2400
9.14m LOTS
GARDEN 3 (GR)
ELEVATION 1, 2 & 3
A1 PACKAGE
O.REG. 332/12

CITY OF CAMBRIDGE BUILDING DIVISION THESE PLANS have been examined for compliance with the Ontario Building Code Requirements. A Building Permit is in order to issue subject to any changes noted under the condition that the building will be constructed in accordance with the code Inspector: Thomas Weathers Date: 2023-03-08

TITLE SHEET	
BARLASSINA CONSTRUCTION CITY OF CAMBRIDGE

ALT.-SEC. FL. PL. EL-3

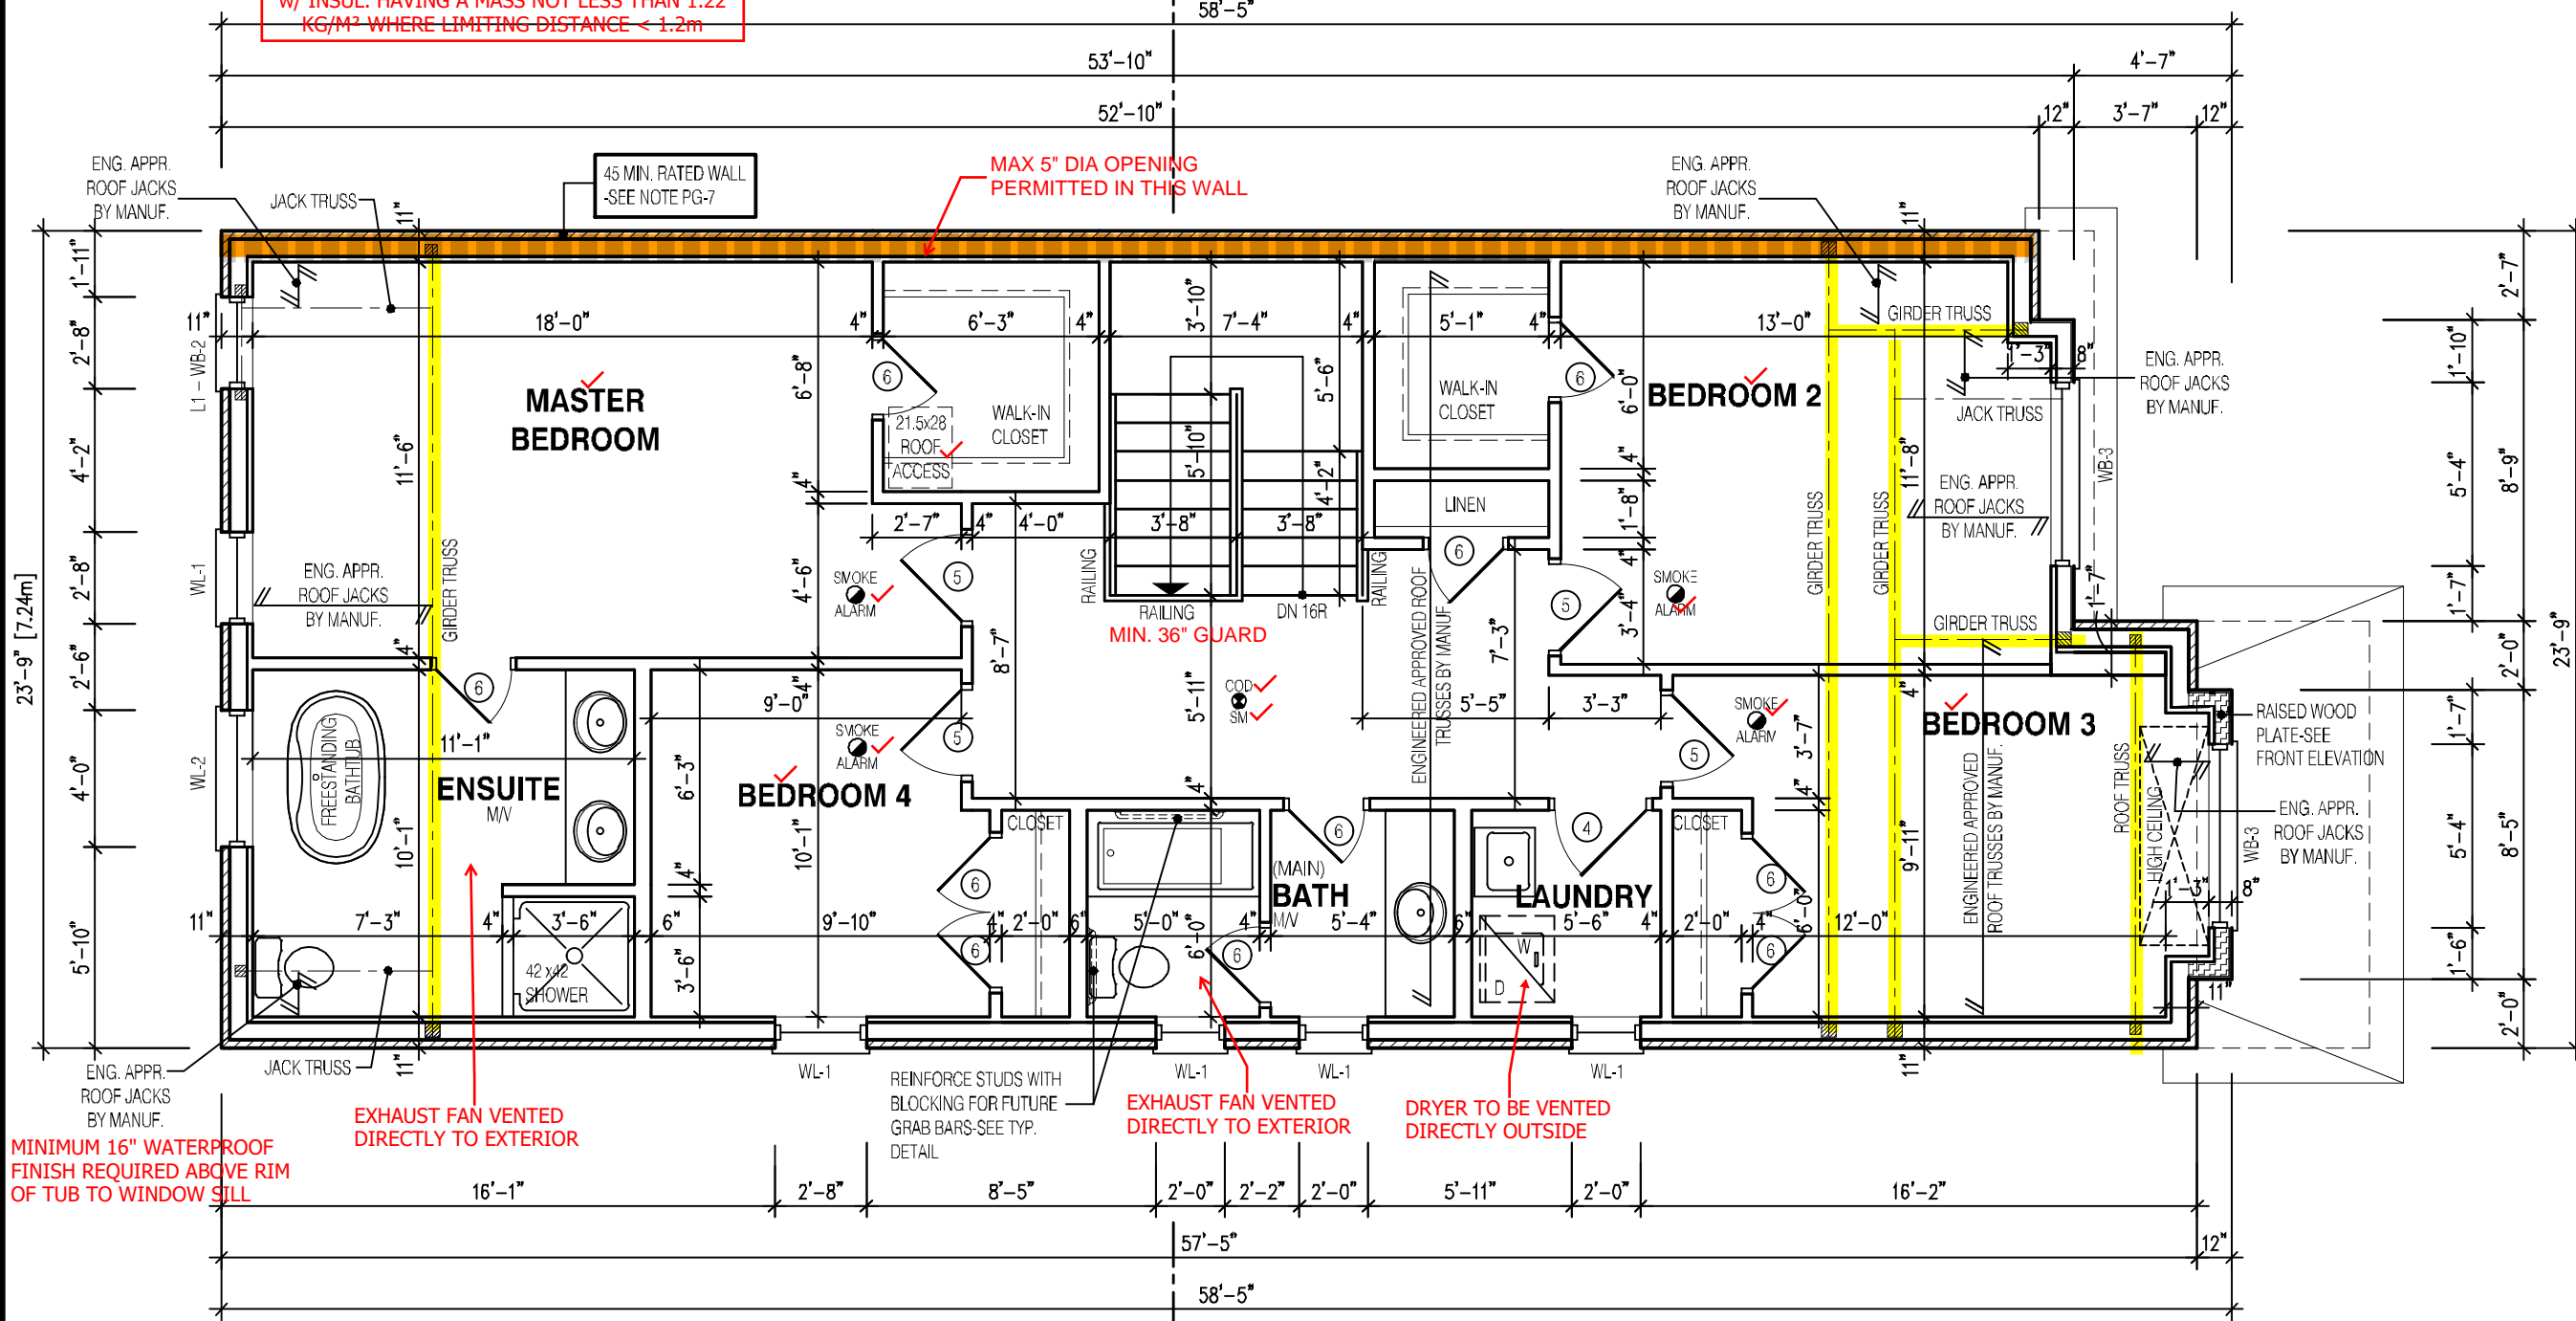
1 WINDOW SHALL PROVIDE AN UNOBSTRUCTED ARE OF 3.85F w/ NO DIMENSION LESS THAN 15". WINDOW SILL TO BE MAX 39-3/8" ABOVE FINISHED FLOOR.

MAIN BATHROOM TO HAVE STUD BLOCKING FOR FUTURE INSTALLATION OF GRAB BARS ADJACENT TO SHOWER/TUB AND TOILET.

REINFORCE STUDS WITH BLOCKING FOR FUTURE GRAB BARS-SEE TYP. DETAIL

REAR ELEVATION 3
ALT.- 4-BEDROOM LAYOUT

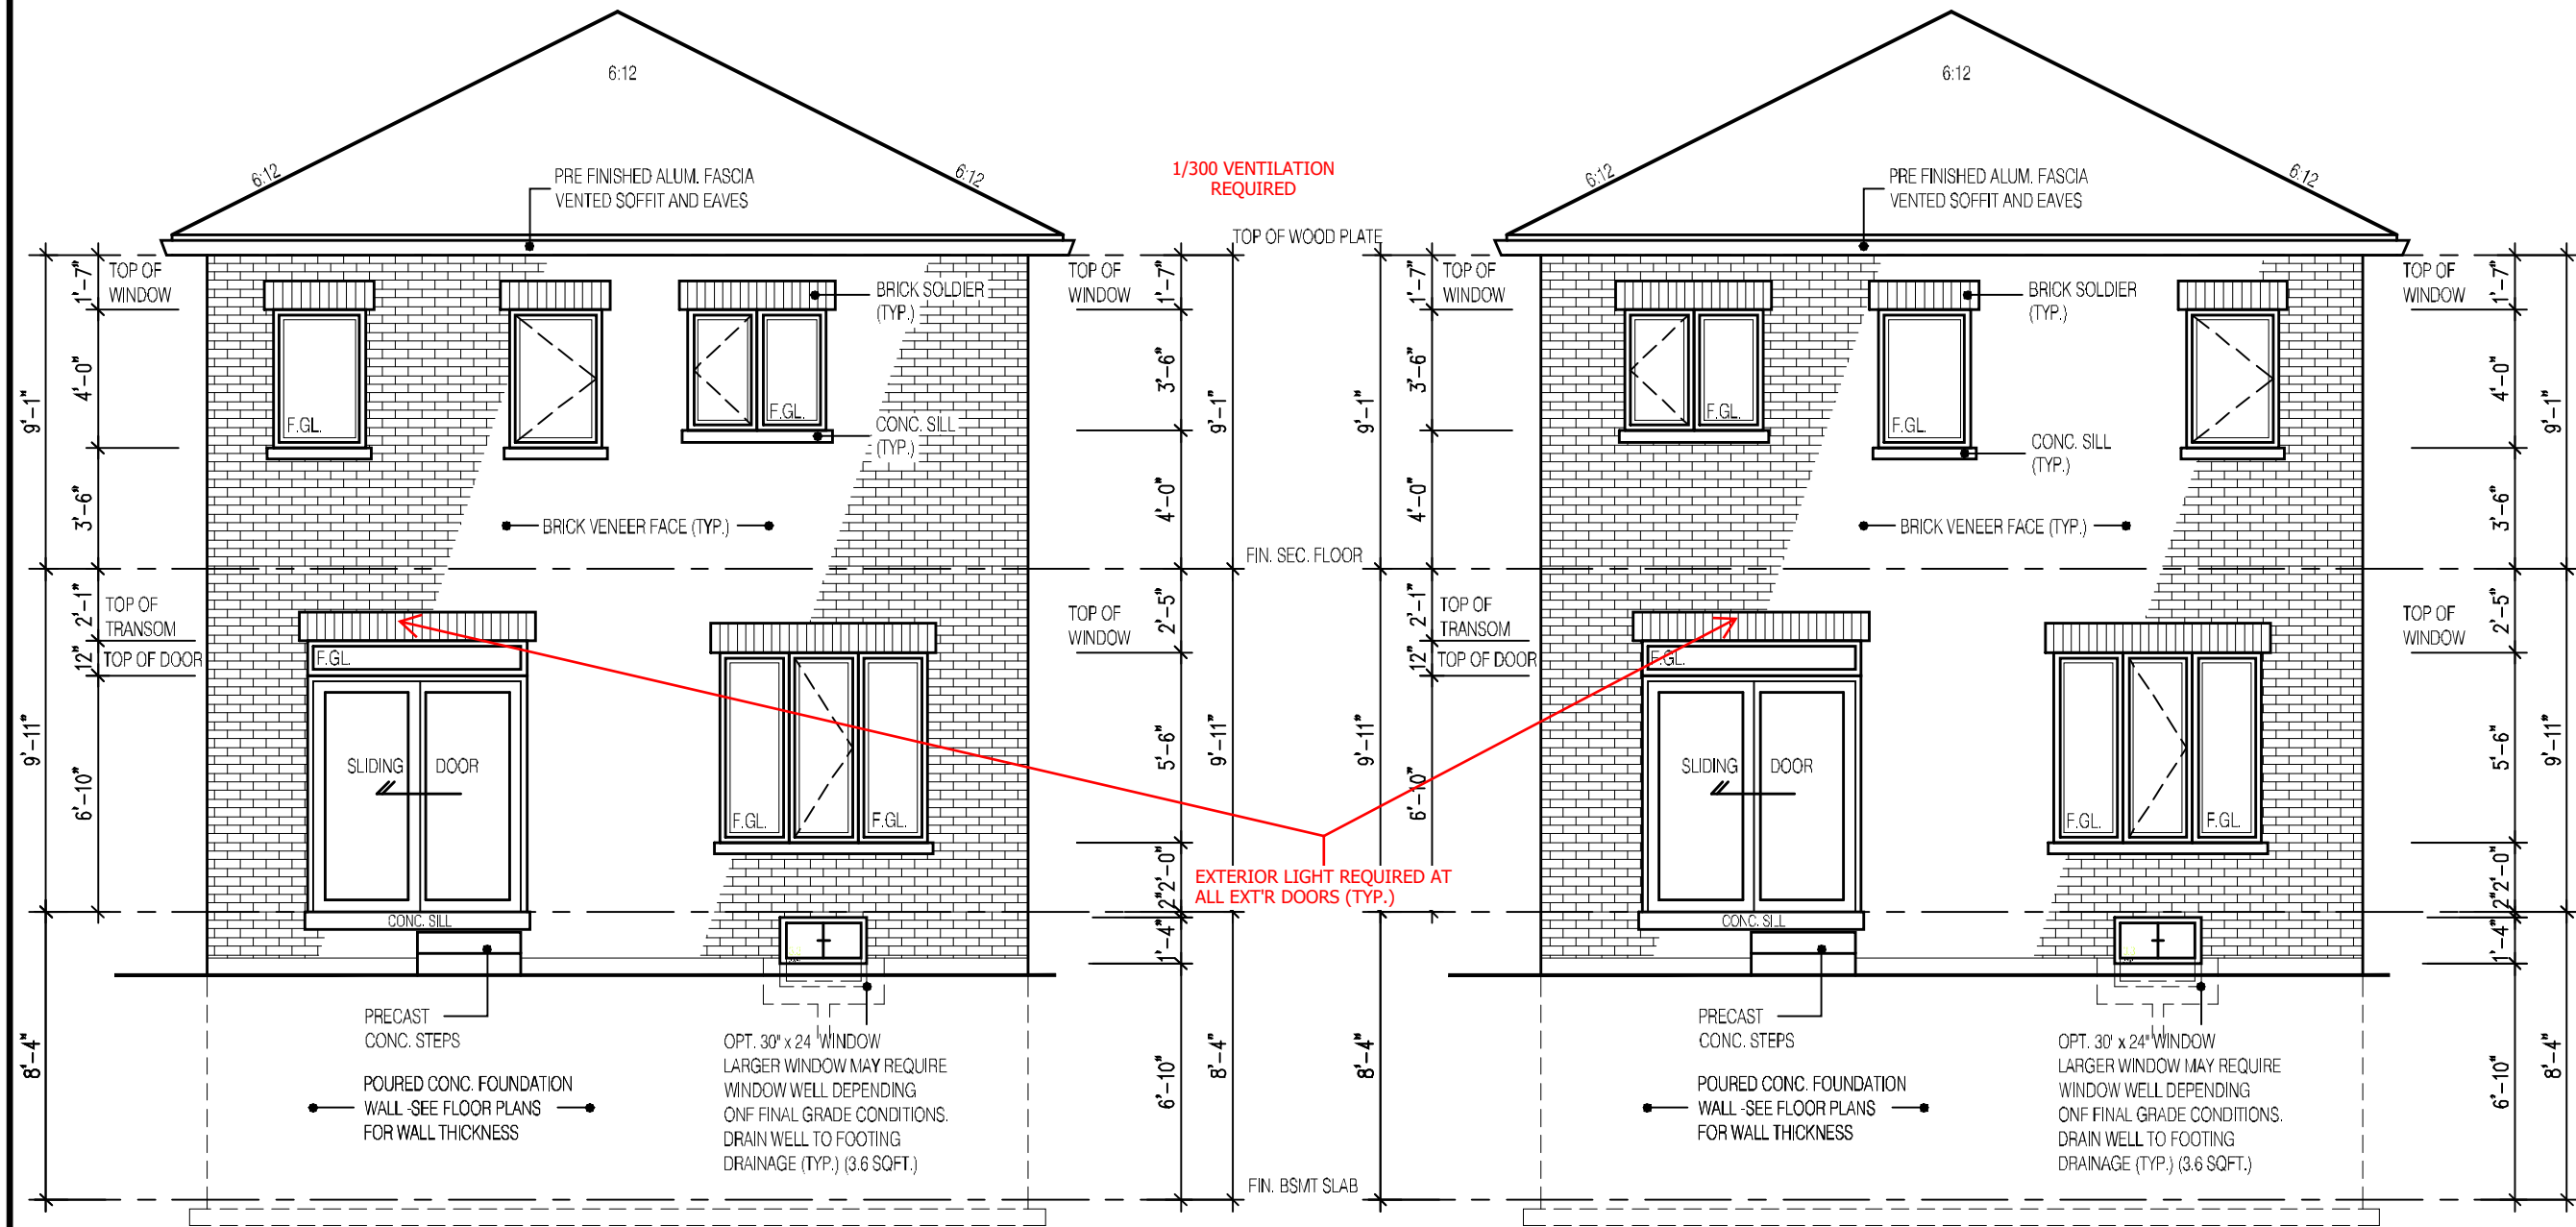
PROVIDE STAIR, GUARD AND LANDING OR
INSTALL PERMANENT BLOCKING TO
RESTRICT DOOR OPENING TO MAX. 4".

DECK CONDITION EL-3

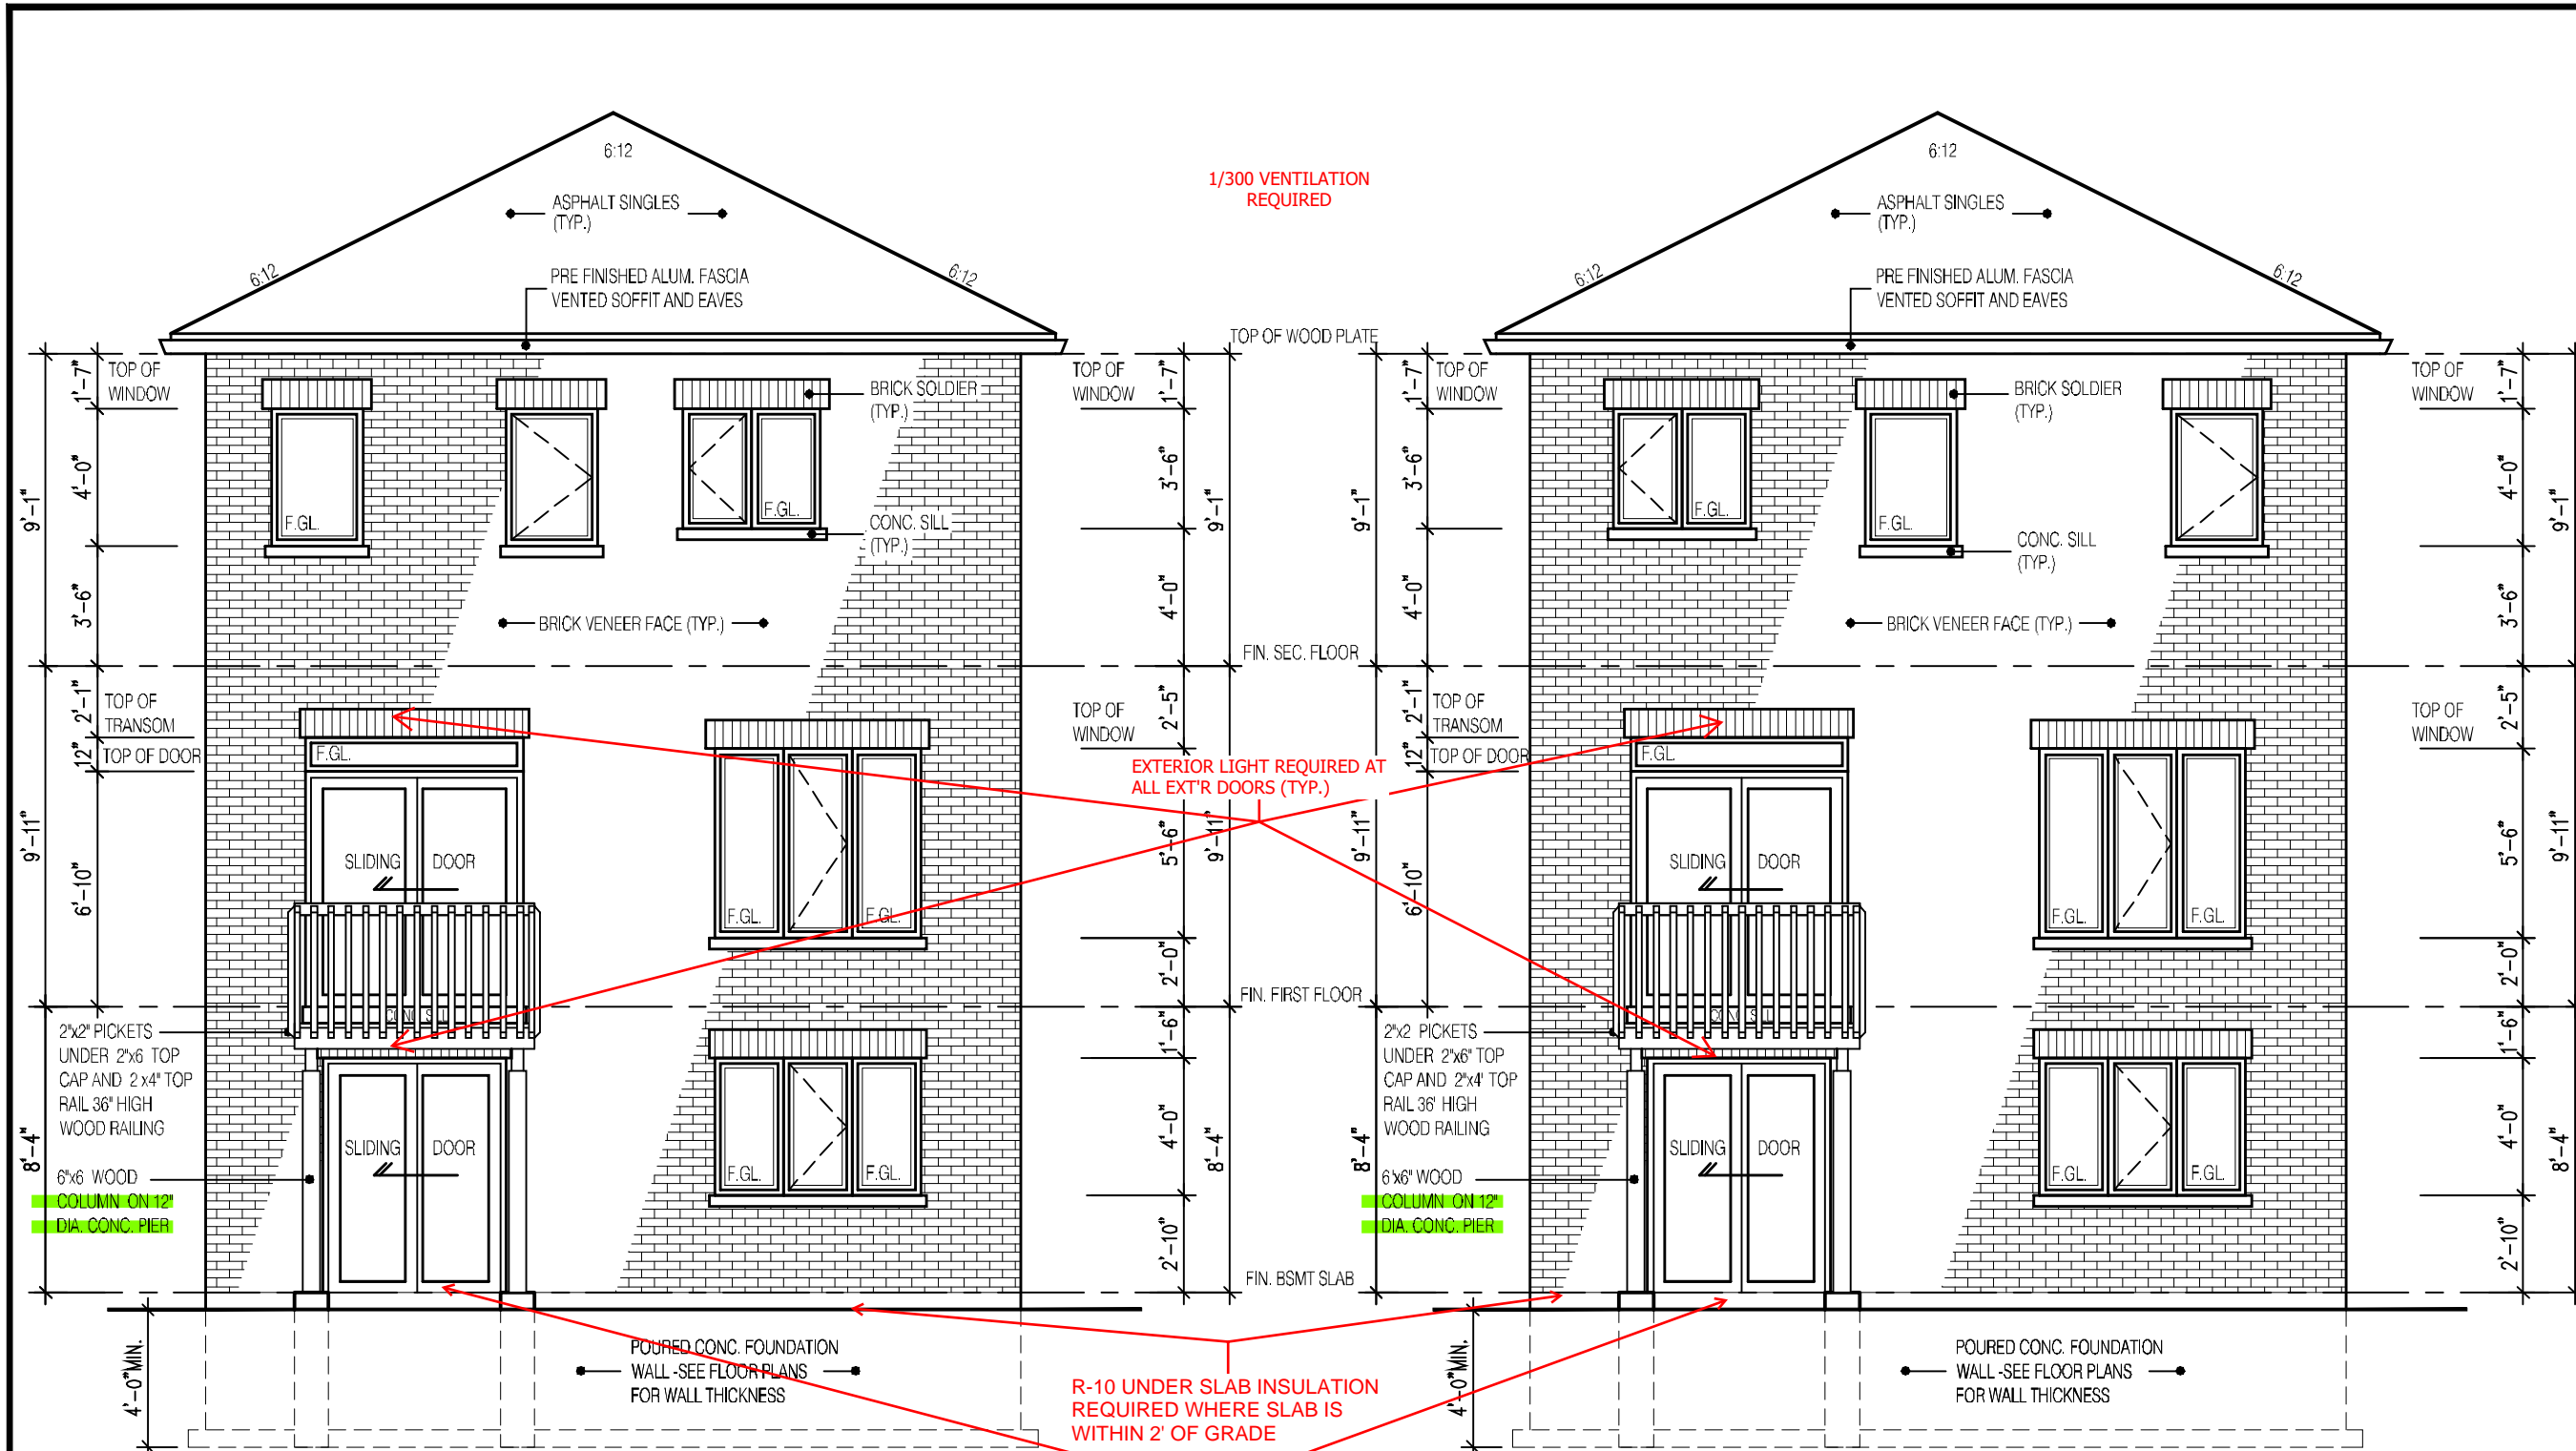
PROVIDE STAIR, GUARD AND LANDING OR INSTALL PERMANENT BLOCKING TO RESTRICT DOOR OPENING TO MAX. 4".
